LICENSING REPORT
DRESDEN NUCLEAR POWER PLANT
UNITS 2 AND 3
SPENT FUEL RACK MODIFICATION

DOCUMENT #: QUAD-1-79-234

REVISION NO. 3

REVISION SHEET

FIGURE 3.2-1. STAINLESS STEEL TUBE
WITH BORAL CORE
FOR DRESDEN FUEL STORAGE

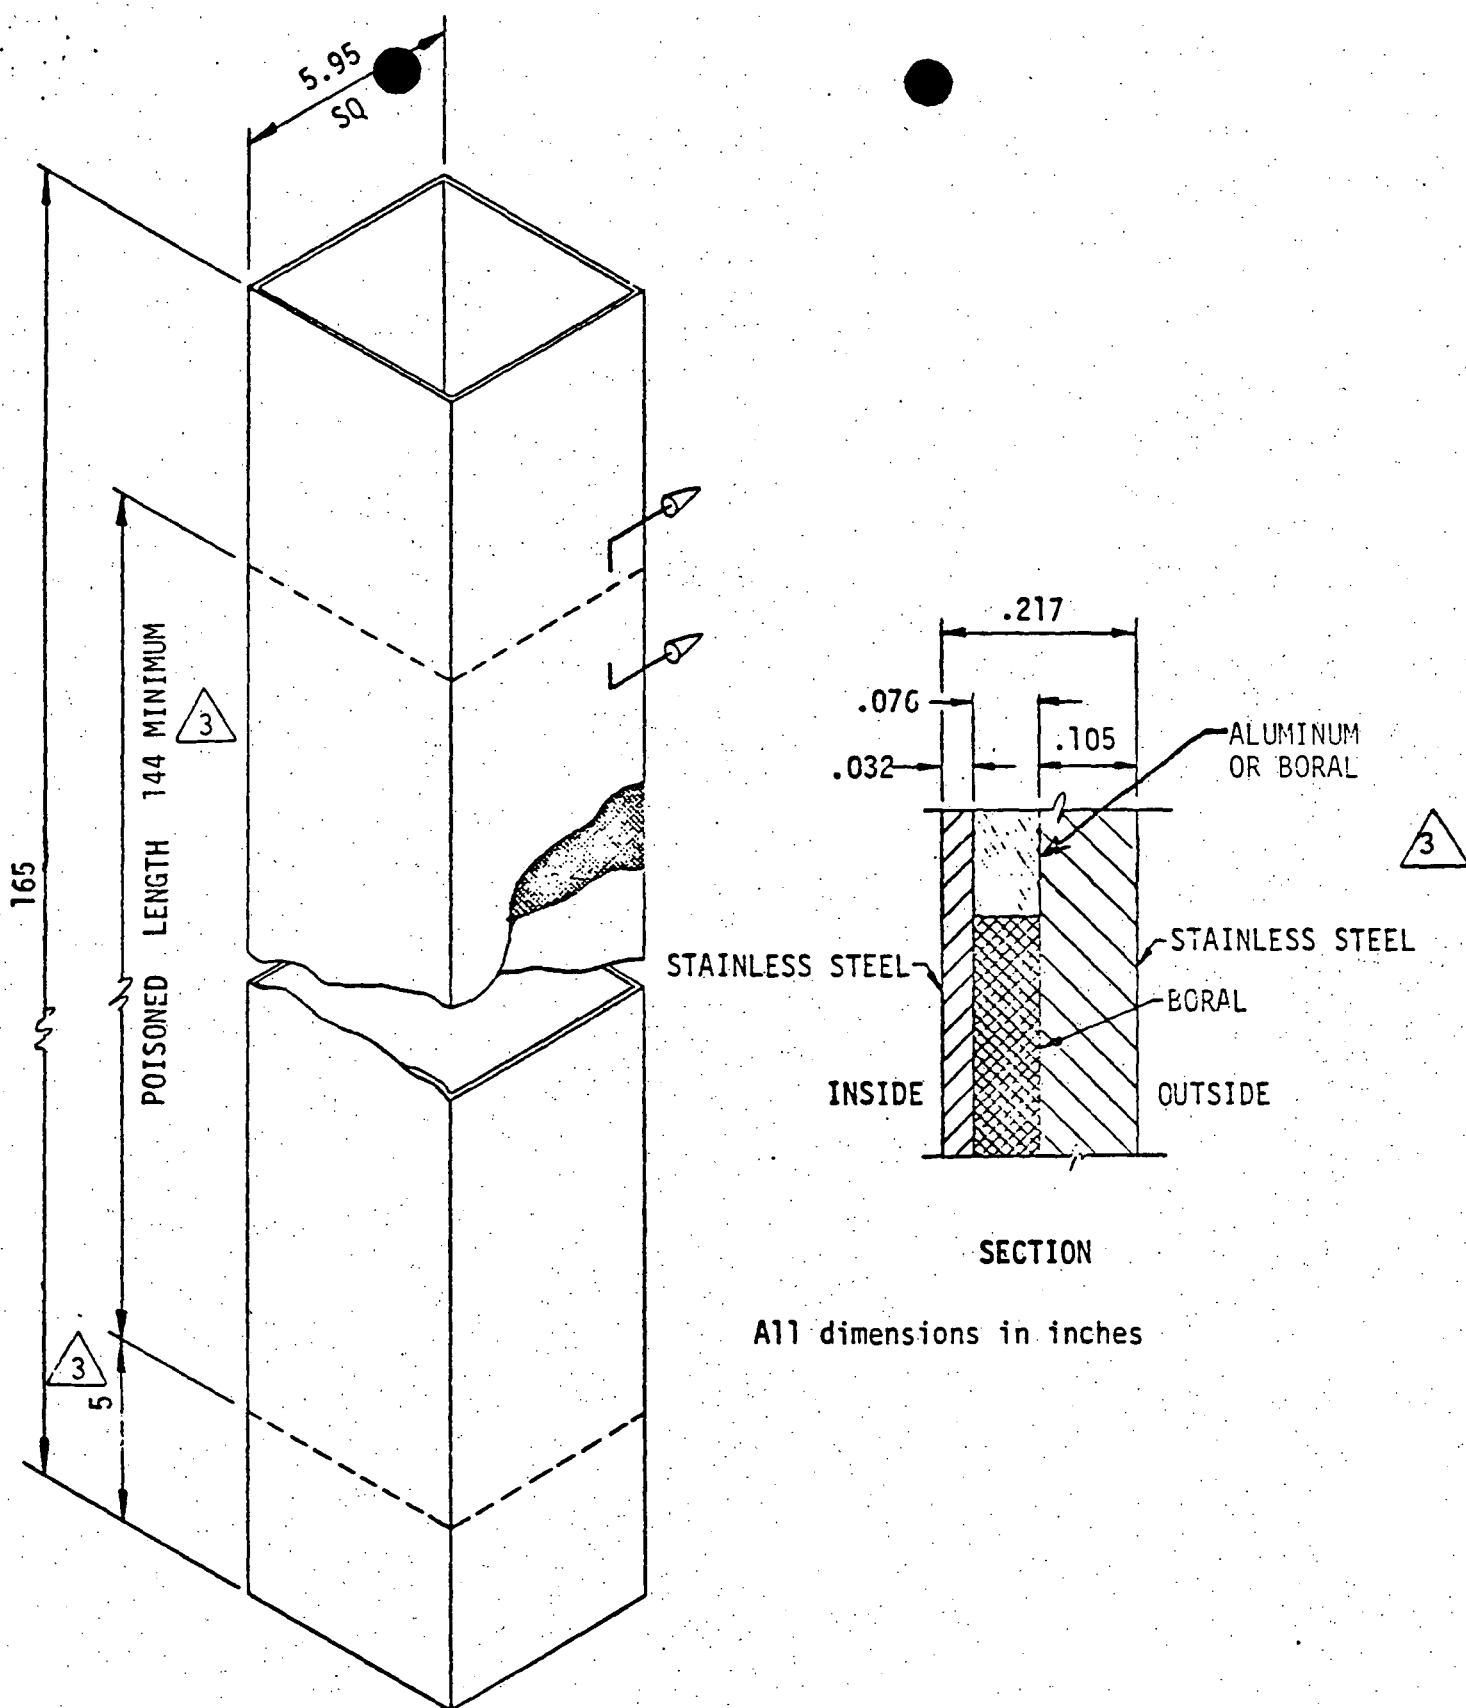
5.	Section 3.2 - Revised number of racks.	3-6
6.	Figure 3.2-1 - Revision of poisoned length from 144 inches to 144 inches minimum and the dimension indicating the location of poison from the bottom of the tube.	3-7

FIGURE 3.2-2. 9 X 13 SPENT FUEL RACK
DRESDEN UNITS 2 AND 3

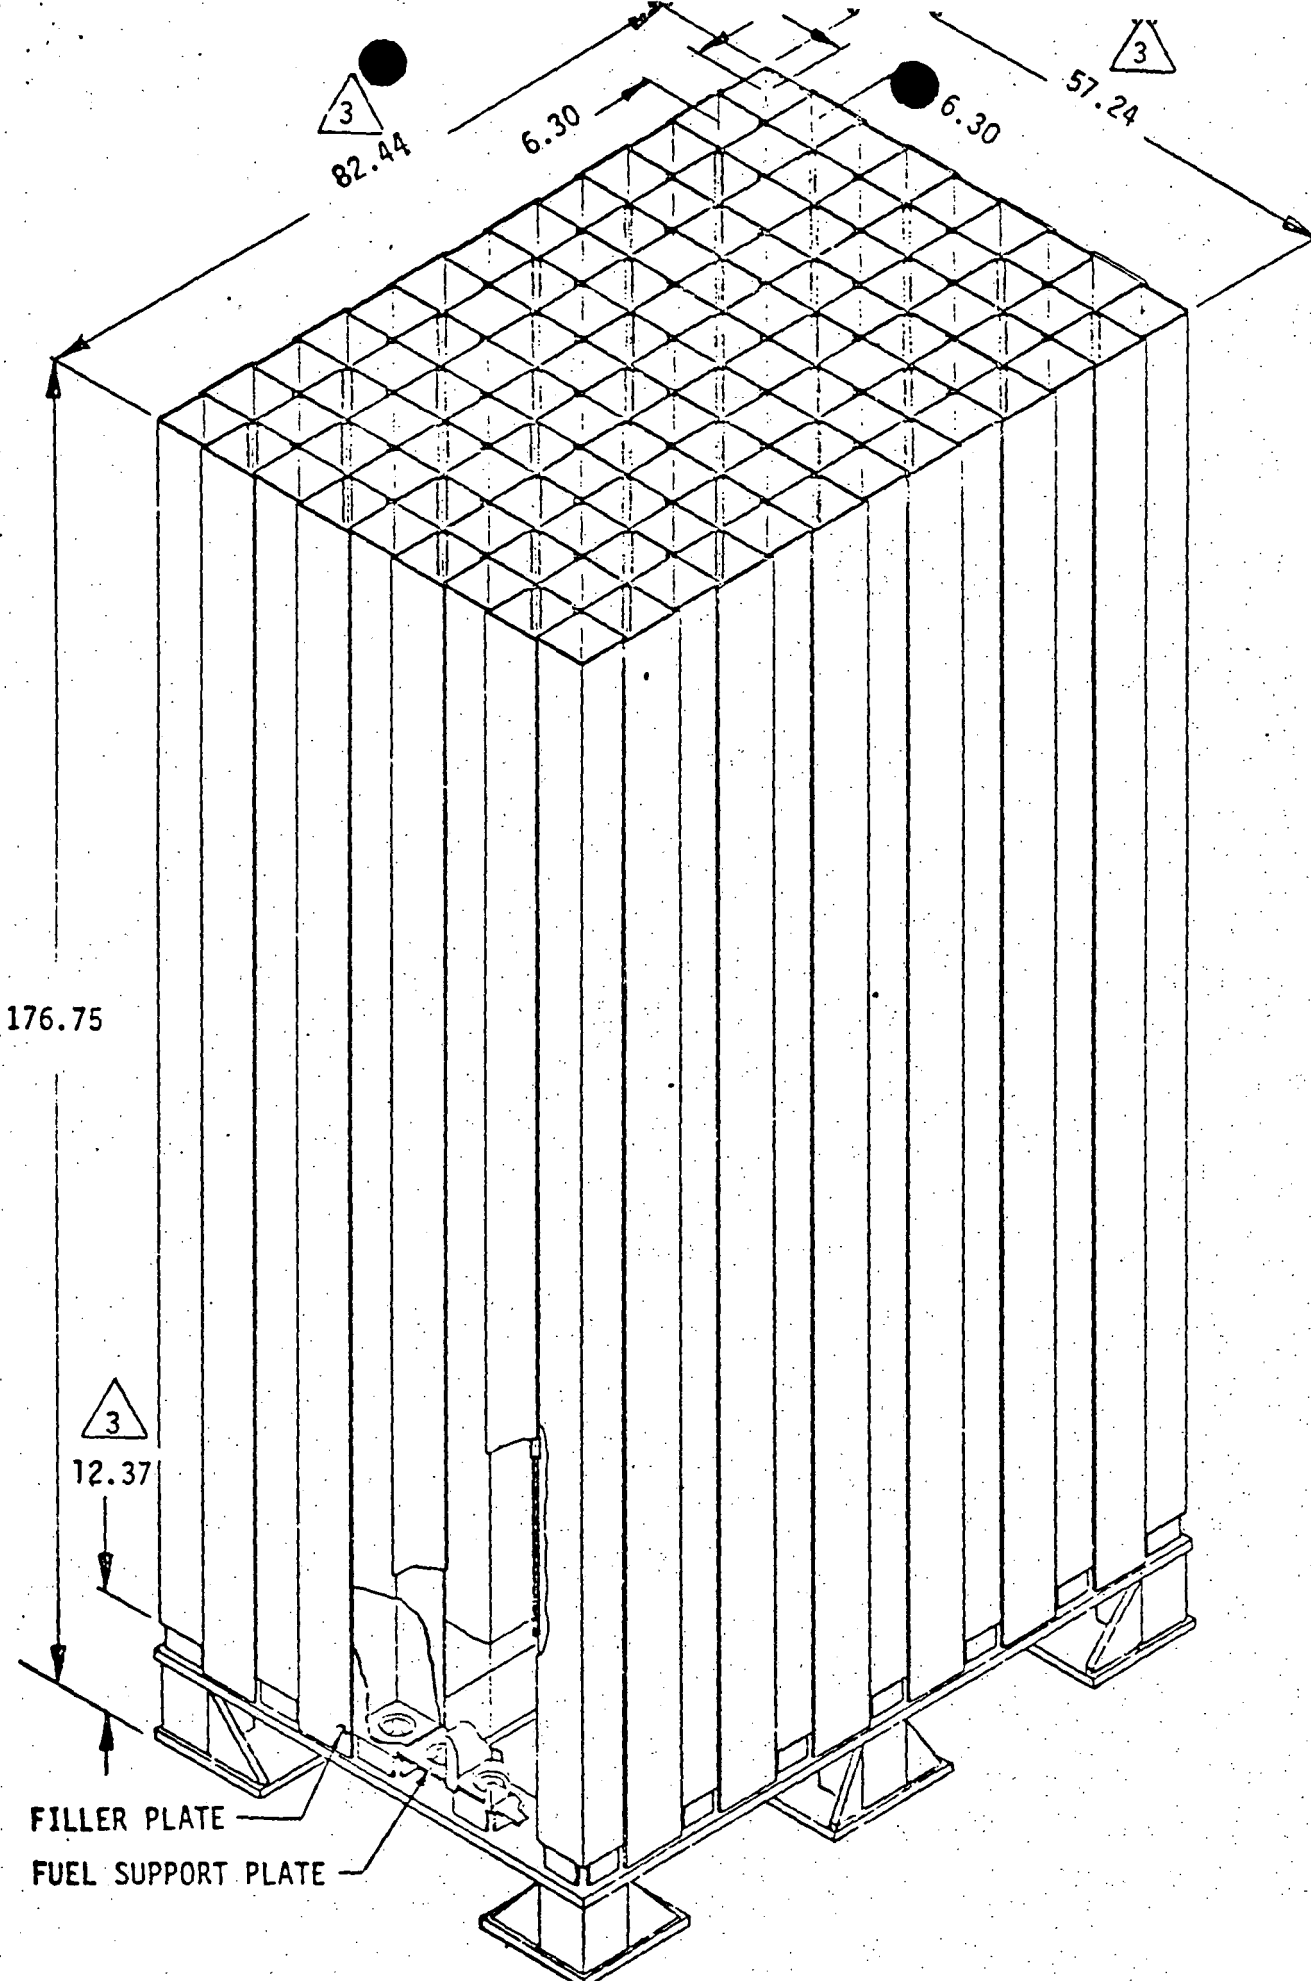
7.	Figure 3.2-2 - Revised overall width of fuel rack and revised elevation of fuel support plate.	3-8
8.	Table 3.3-1 - Revised Δk_3 and k_{eff} .	3-10
9.	Section 3.3.5 - Revised k_{eff} for condition 5.	3-16

FIGURE 3.3-6. RACKS IN CONTACT WITH EACH OTHER

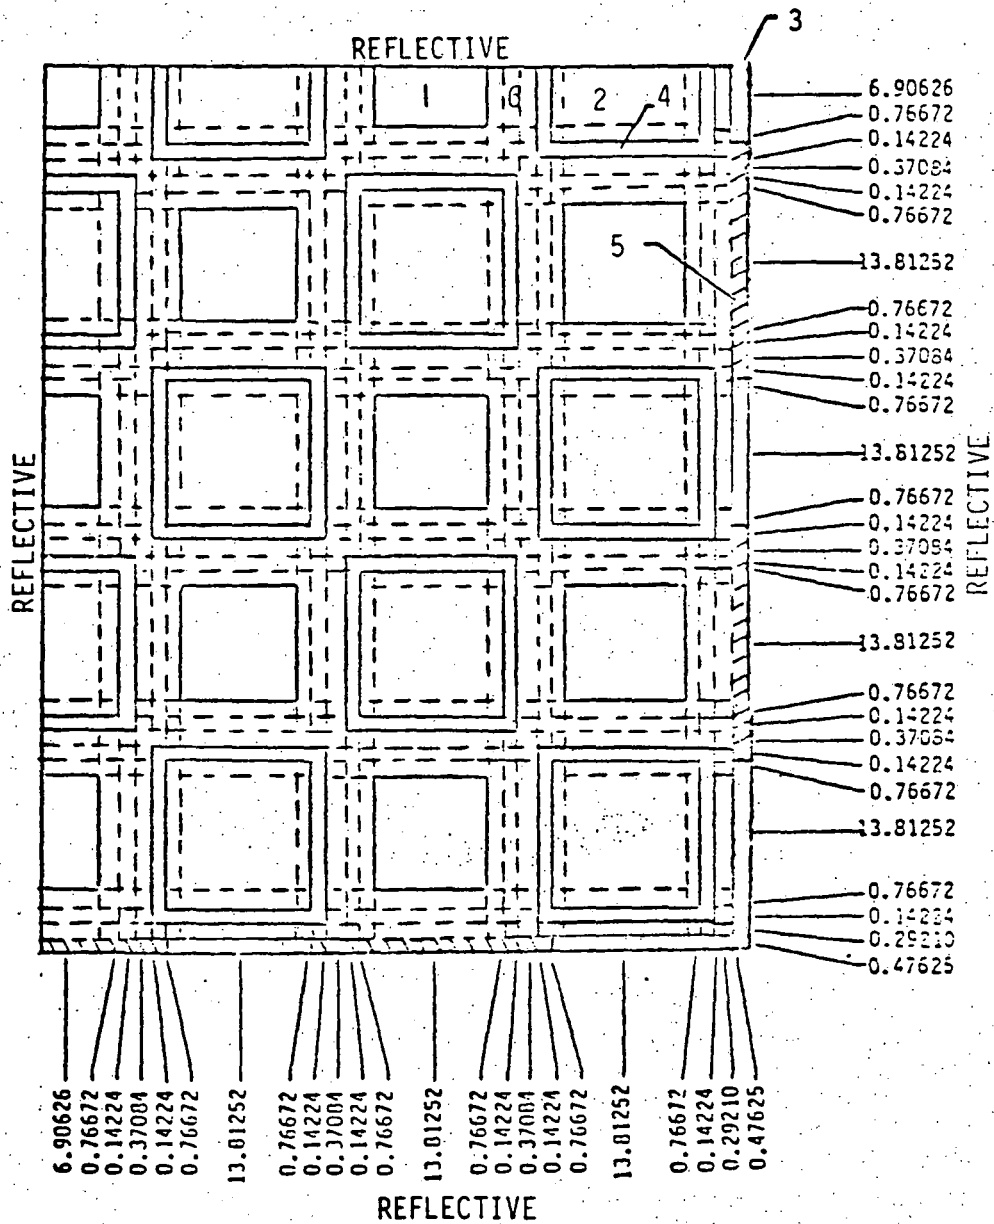
10.	Figure 3.3-6 - Revised figure to reflect the correct geometry of the fuel racks.	3-26
11.	Figure 3.3-9 - Revised figure to include k_{eff} at a pitch of 6.2 inches.	3-29

FIGURE 3.6-8: DRESDEN FLOW MODEL NATURAL CIRCULATION

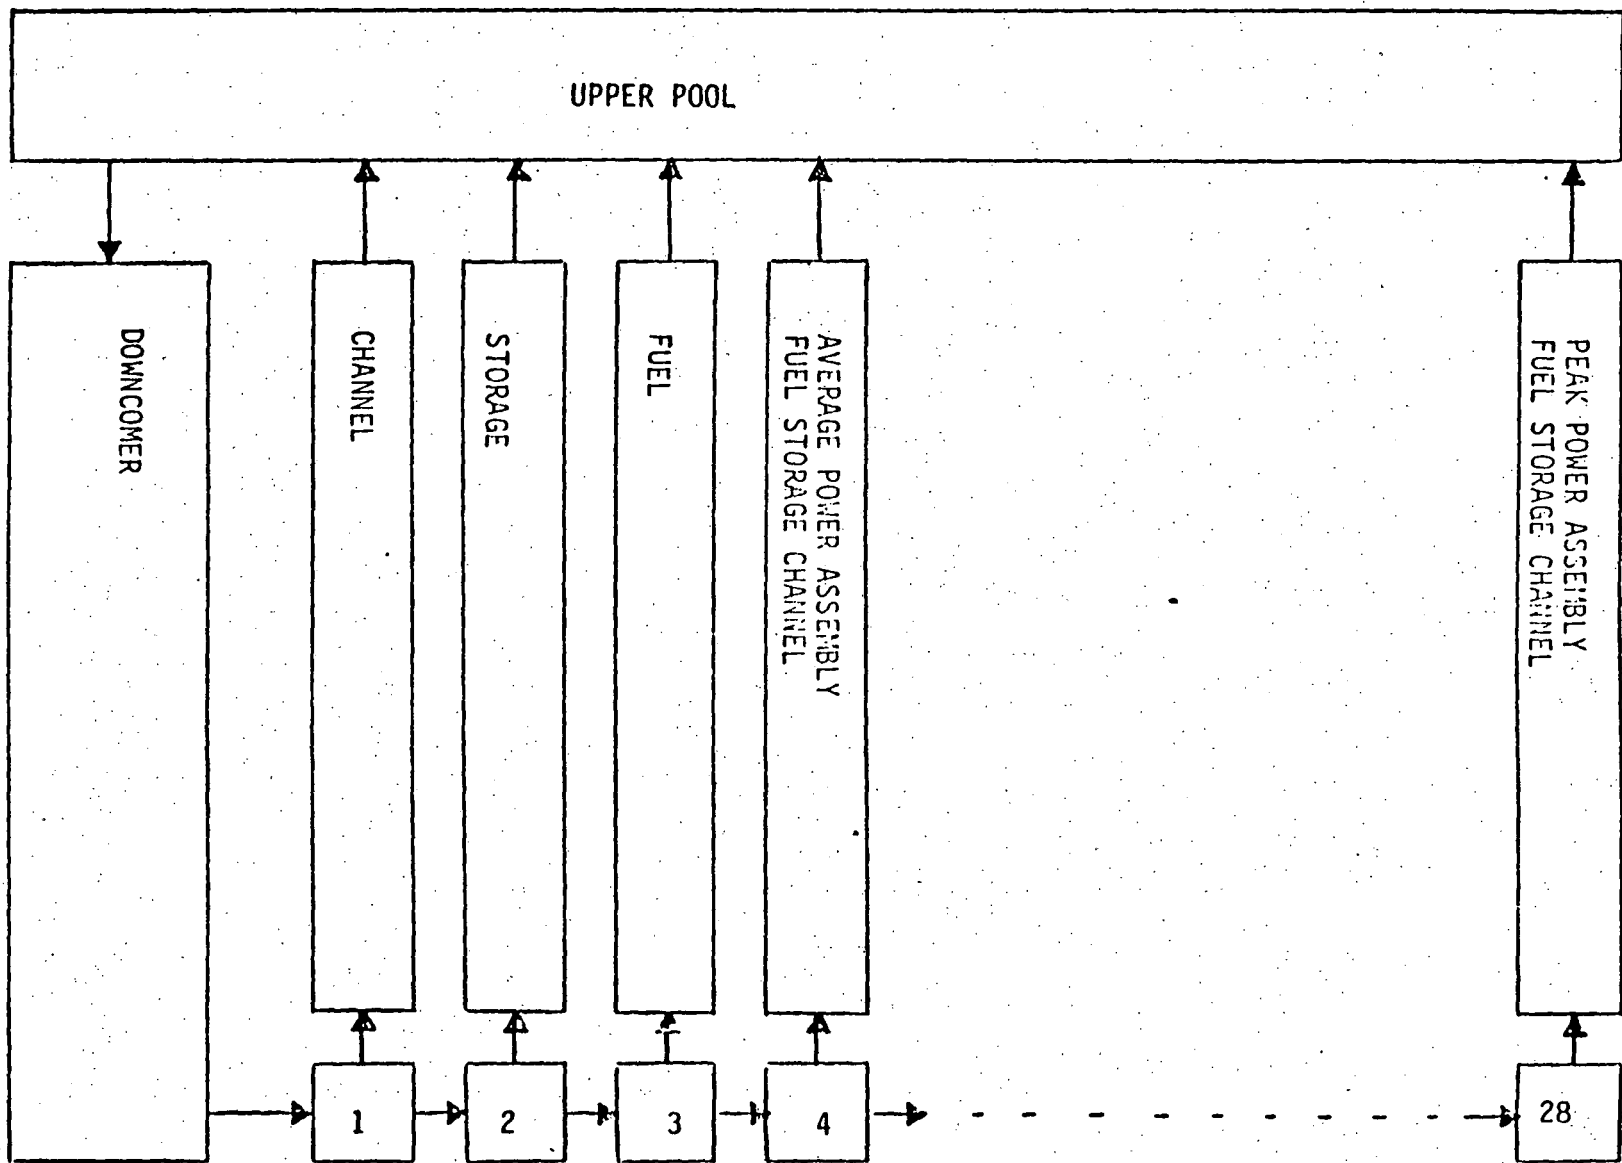
12.	Figure 3.6-8 - Number of flow channels changed from 30 to 28.	3-64
13.	Figure 3.6-9 - Revised fuel storage pool arrangement.	3-65
